INDIANA & MICHIGAN POWER COMPANY

Donald C. Cook Nuclear Plant Unit Nos. 1 & 2
Docket Nos. 50-315 & 50-316
DPR No. 58 and CPPR No. 61

Mr. Edson G. Case, Acting Director
Office of Nuclear Reactor Regulation
U.S. Nuclear Regulatory Commission
Washington, D.C. 20555

Figure 1. Steam Generator Lower Support Model

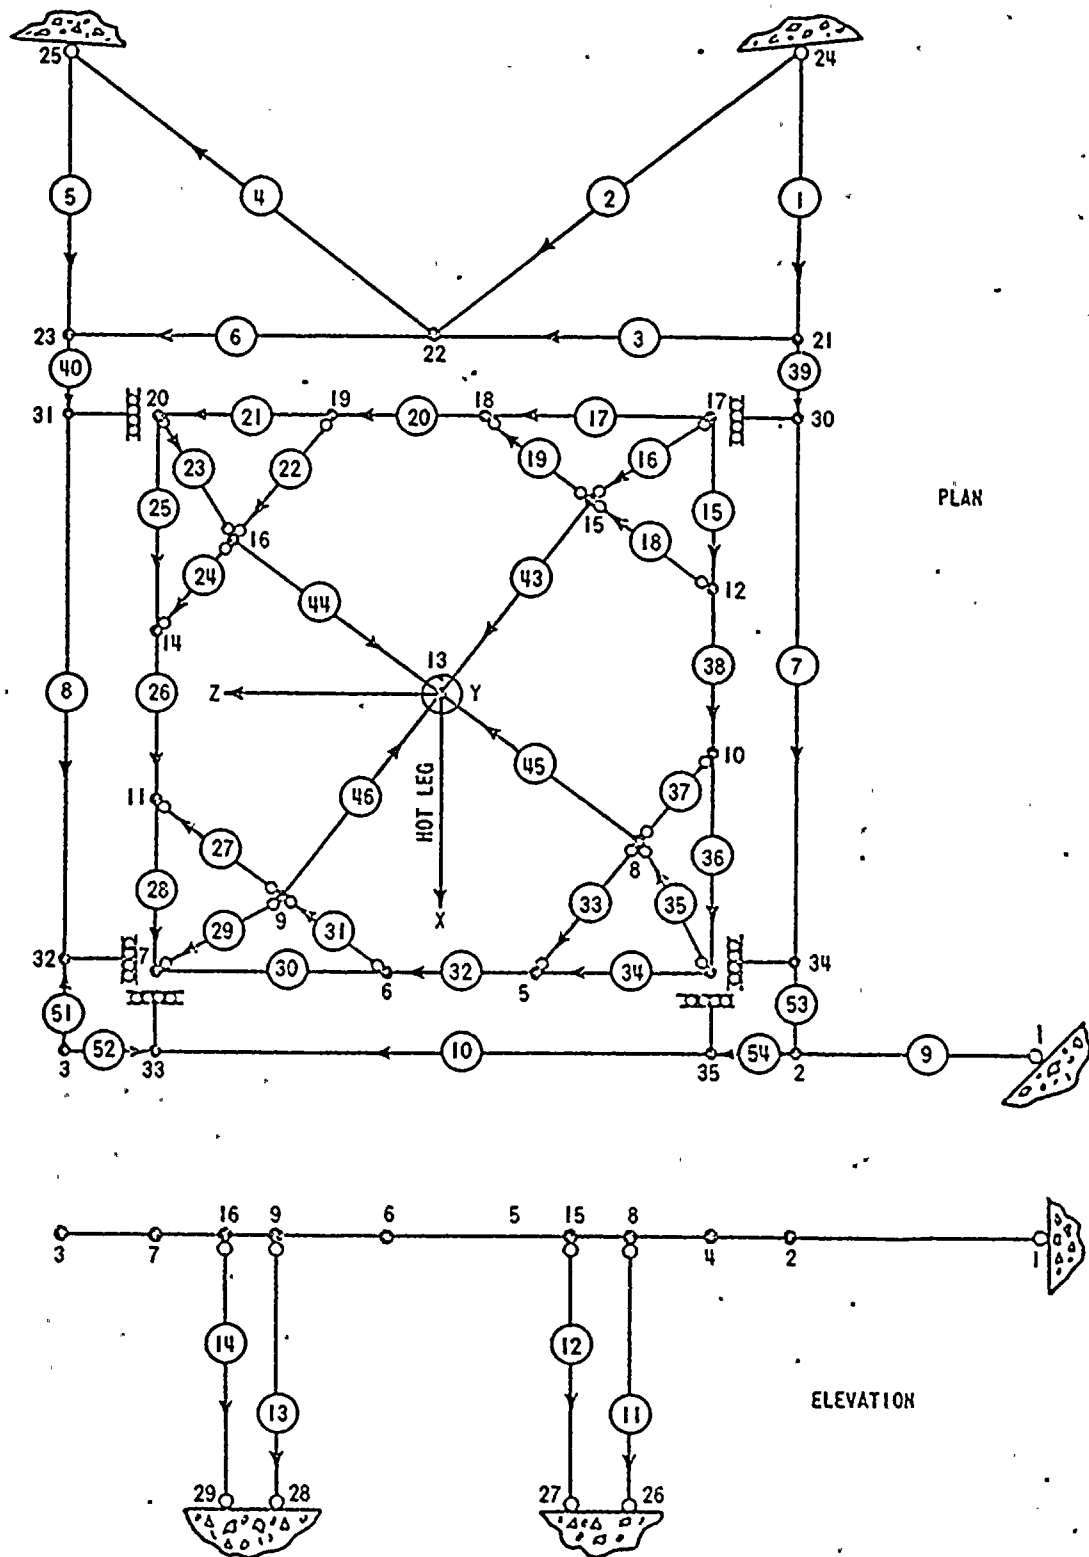
Specify the detailed design loads used in the analysis and design of the supports. For each loading condition (normal, upset, emergency and faulted), provide the calculated maximum stress in each principal elements of the support system and the corresponding allowable stresses.

The detailed design loads as provided by Westinghouse for the steam generator in report SD104 are given in the first 13 tables. Member stress levels expressed as a percentage of the allowable stress for the upper and lower supports are provided in tables 14 and 15. Figures 1 and 2 are provided to identify the elements of the steam generator supports. The loads for the Reactor Coolant pump supports are provided in tables 16 through 26. Tables 18 through 26 include both the loads and the margin of safety under the faulted condition for the R.C. Pump supports. Figure 3 is provided to identify the members. Stress levels for the R.C. Pump supports for the load cases normal, upset and emergency are provided in Table 27. Figure 3 identifies the elements for Table 27. The allowable stresses for each load condition and a description of the loading conditions themselves are provided in the following paragraphs.

In all cases the faulted condition controls the design. The maximum stress level found for the faulted condition for the steam generator lower lateral support was 84% of the maximum

+See Figure 1 for member locations.
